Environmental
Protection
Authority

Gorgon Gas Development and Janz Feed Gas Pipeline – Inquiry
under Section 46 of the *Environmental Protection Act 1986*
to amend the implementation conditions of Ministerial
statements 769, 800, 965, and 1002 relating
to the emission of greenhouse gases

Chevron Australia Pty Ltd

Report 1729
September 2022

Figure 1: EPA’s recommended GHG emissions reduction trajectory

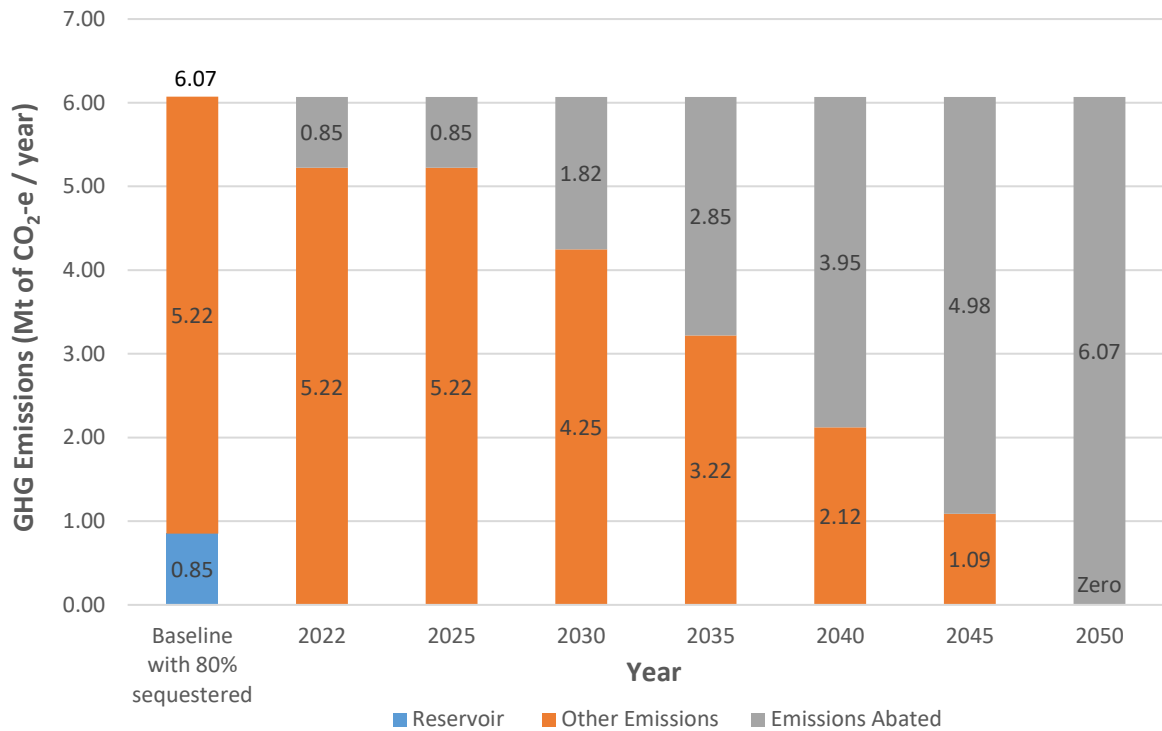
- Chevron's proposed trajectory relies heavily on the injection of reservoir CO₂.
- It is generally consistent with Chevron having already been required to implement best practice and ongoing review and adopt advances in technology and operations for the processing plant as per existing condition 27.2.

- Offsets are permitted if Chevron does not meet the trajectory.

The EPA's recommended trajectory is shown in Figure 1 below.

- A recommended baseline quantity of 6.073 Mtpa of CO₂-e / year which excludes the injection of 80% of reservoir CO₂ (i.e. 3.4 Mt of CO₂-e / year) given that Chevron should already be injecting at this rate (See Figure 1 above).

The EPA recommends that a baseline GHG emissions quantity of 6.073 Mt of CO₂-e / year (which excludes the injection of 80% of reservoir CO₂ (i.e. 3.4 Mt of CO₂-e / year) is appropriate in this case as it takes into account that Chevron should have already been injecting at least 80% of reservoir CO₂ at this point in time (see Figure 1).
